### APPEAL SUMMARY

Appeal ID: 14747	<b>Project Address:</b> 5313 & 5327 N Interstate Ave, 1518 N Williamette Blvd
Hearing Date: 3/8/17	Appellant Name: Andrew Reiter
Case No.: P-005	Appellant Phone: 503-597-3222
Appeal Type: Plumbing	Plans Examiner/Inspector: Chuck Luttman
Project Type: commercial	Stories: 7 Occupancy: Residential Construction Type: Commercial
Building/Business Name: Williamette Apartments	Fire Sprinklers: No
Appeal Involves: Erection of a new structure,Reconsideration of appeal	LUR or Permit Application No.: 16-279600-CO
Plan Submitted Option: pdf [File 1] [File 2] [File 3]	Proposed use: Apartments

**Project:** Willamette Apartments 5313 & 5327 N Interstate, 1518 N Willamette Blvd (5325 N. Interstate

Re: Plumbing appeal decision

3 A8" INFILTRATION MANHOLE DETAIL

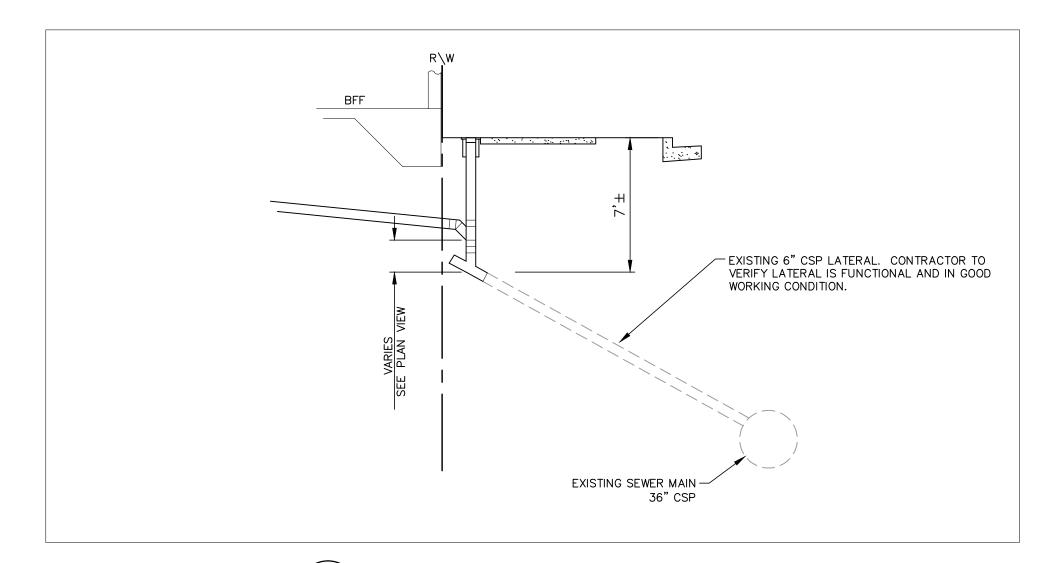
The Infiltration Manhole is 4 feet in width. An 8 inch PVC pipe will be used for inflow. The drywell is approximately 17 feet in depth and 8 feet in width. The lower 10 feet is perforated for infiltration. Approximately 1 1/2" - 3/4" drain rock will be used.

The outer wall of drywell to the building is approximately 1.46 ft and to the center of the drywell is approximately 5.46 ft. The drywall location does not meet the 10 foot setback from the building. A structural engineer will ensure the building will have the structural elements to achieve stability.

Based on the information provided to PSI, we understand the dry well structure and associated backfill is proposed 3'-4" and 5'-3" from the edge of the building foundation. Based on our review of the provided plans and our above referenced geotechnical report and infiltration testing letter, the proposed drywell is sufficiently set back from the proposed building foundation and does not require additional foundation bearing recommendations at this time. PSI should review any further changes to the planned drywell location if alternate locations are proposed.

## Reduced setbacks for drywell: Granted as proposed

The Administrative Appeal Board finds that the information submitted by the appellant demonstrates that the approved modifications or alternate methods are consistent with the intent of the code; do not lessen health, safety, accessibility, life, fire safety or structural requirements; and that special conditions unique to this project make strict application of those code sections impractical.

SITE UTILITY PLAN

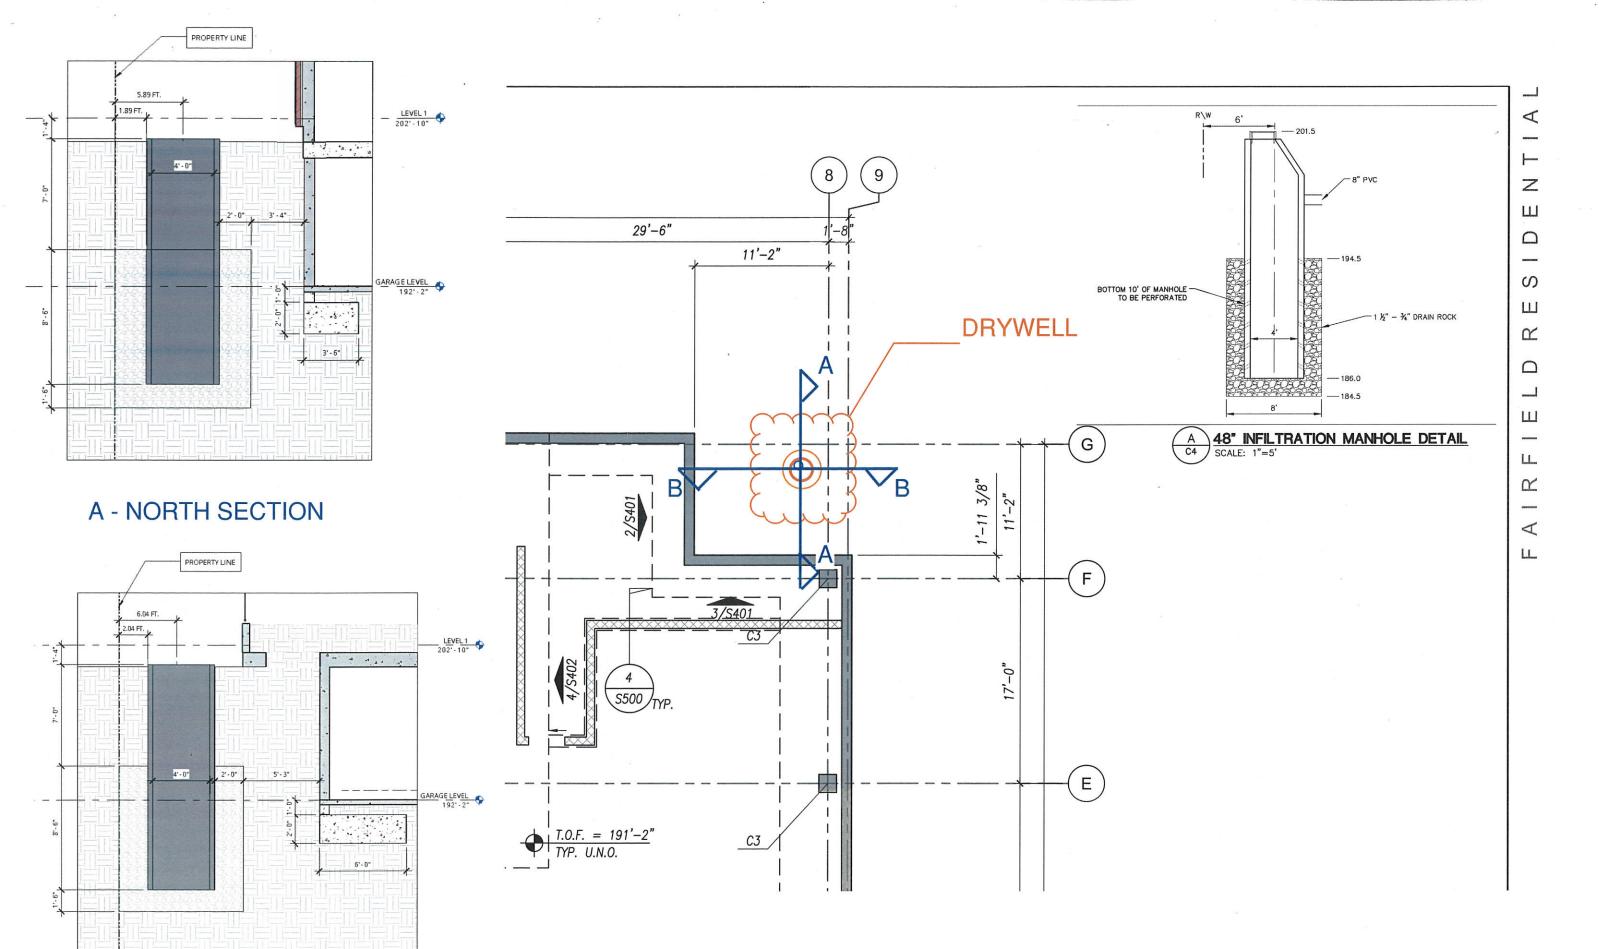
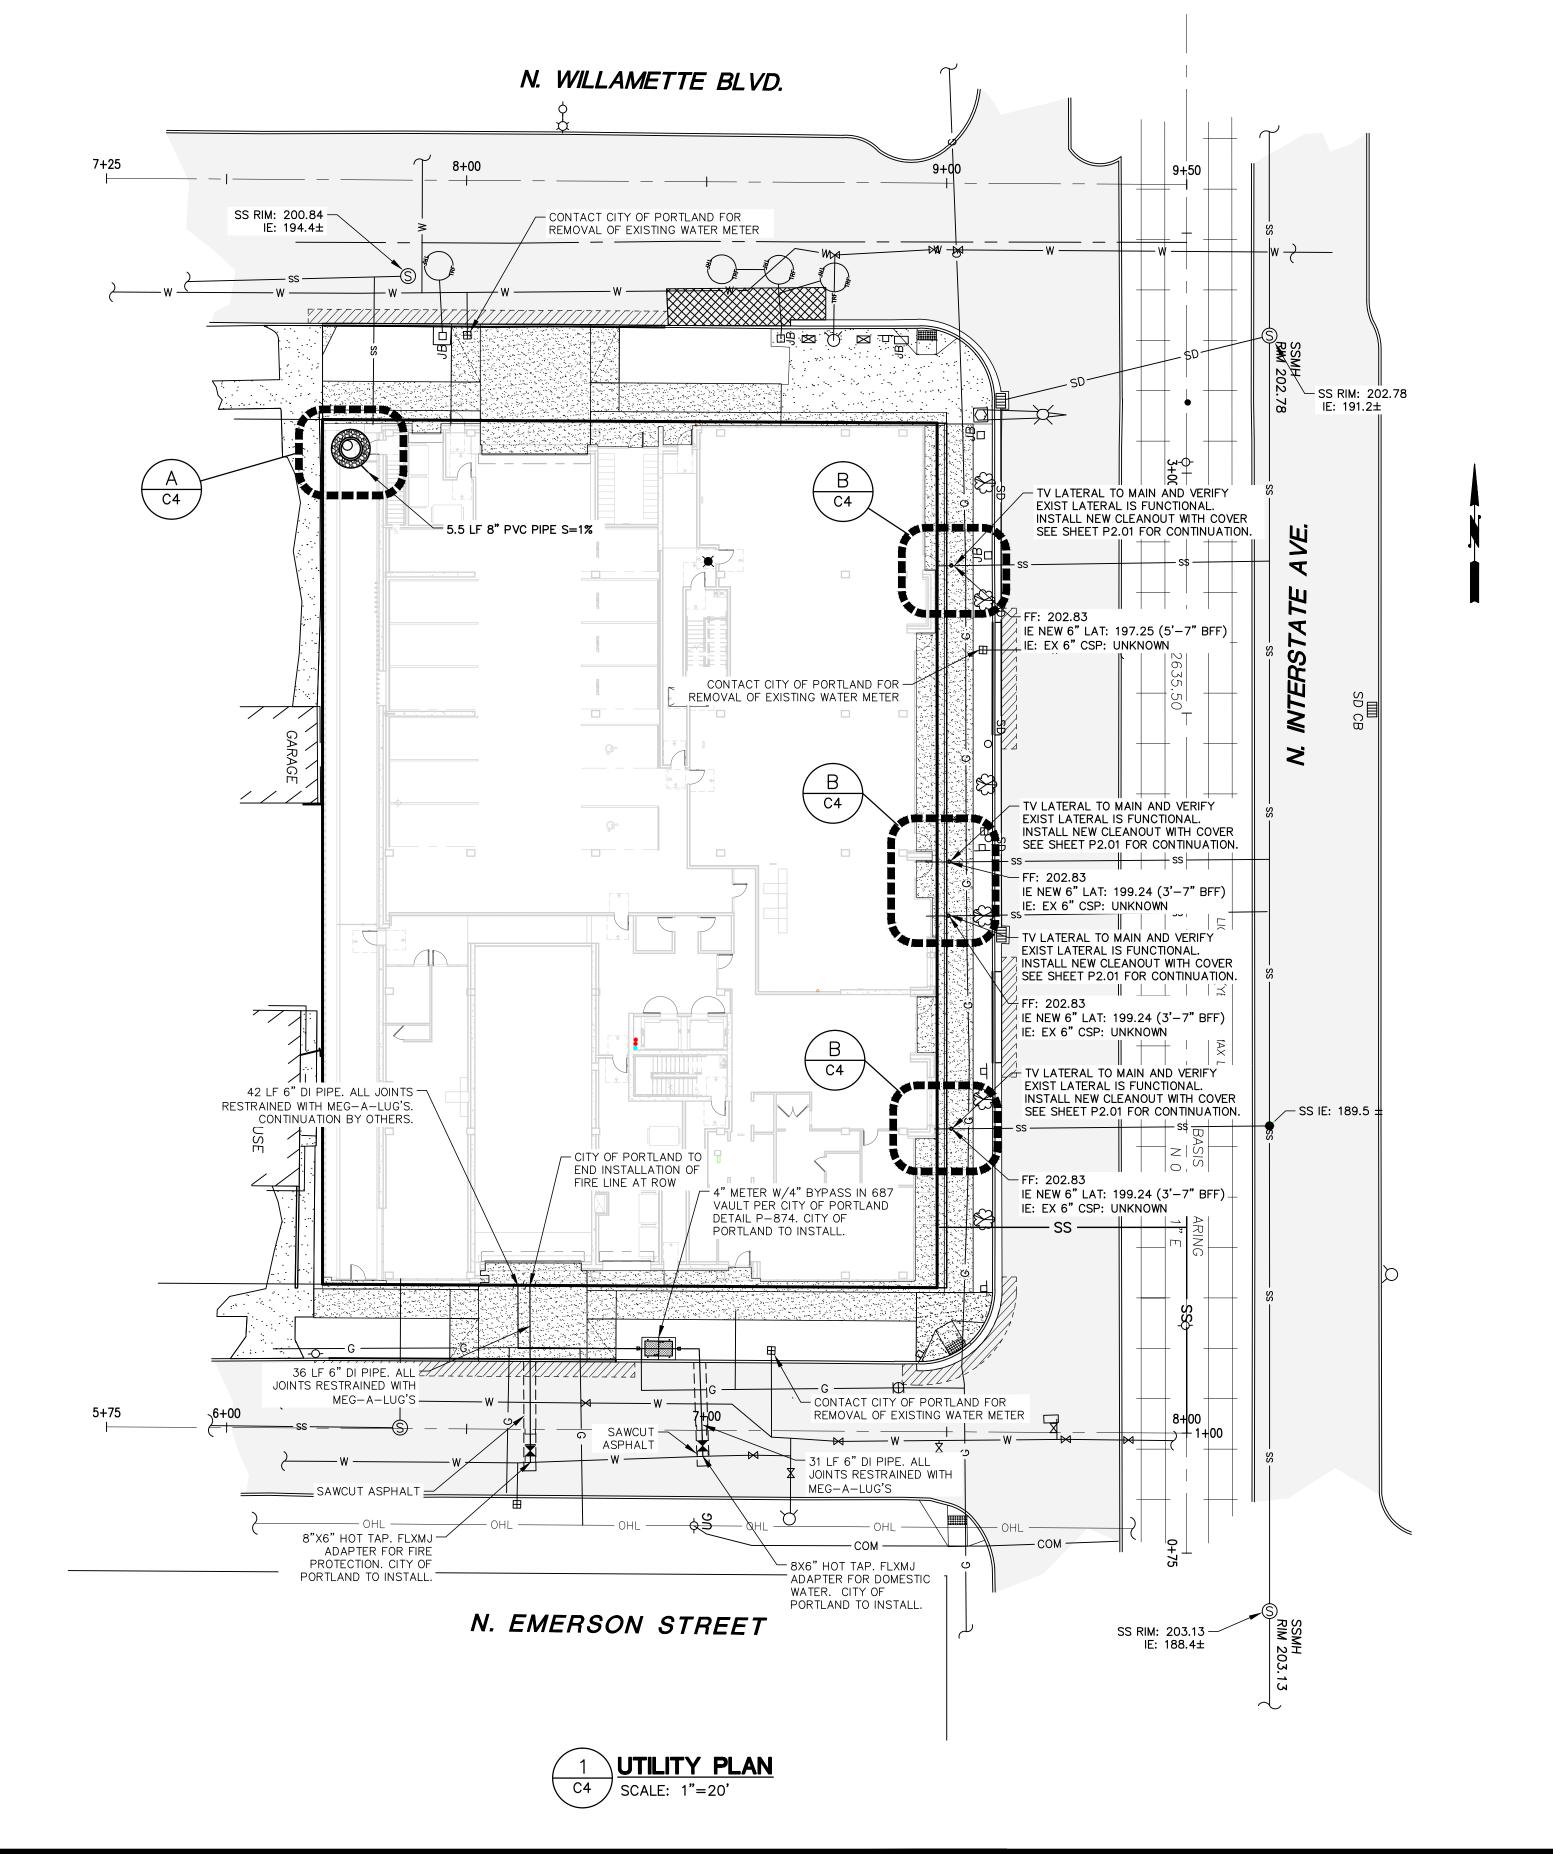
Due to the design constraints of the building footprint, we are unable to meet the City's setbacks for a drywell, which are 10 feet from building and 5 feet from right-of-way.

The outer wall of drywell to the western property corner (right-of-way) is approximately 1.89 ft and to the center of the drywell is approximately 5.89 ft. The drywell location meets the setback for the right-of-way.

The outer wall of drywall to the northern property corner (right-of-way) is approximately 2.04 ft and to the center of the drywell is approximately 6.04 ft. The drywell location meets the setback for the right-of-way.

P-1: Location of drywell: Denied. Piped overflows from private drywells to the City's sewer are not allowed. Additionally, structural engineer's report required regarding impact on foundation system.

**Response:** The drywell was designed to handle the 100 year storm event.

If or when the drywell fails, the flow will be released through the manhole cover. It will drain overland to the curb. There will be clear indicators of the failure, therefore requiring remedial repairs.
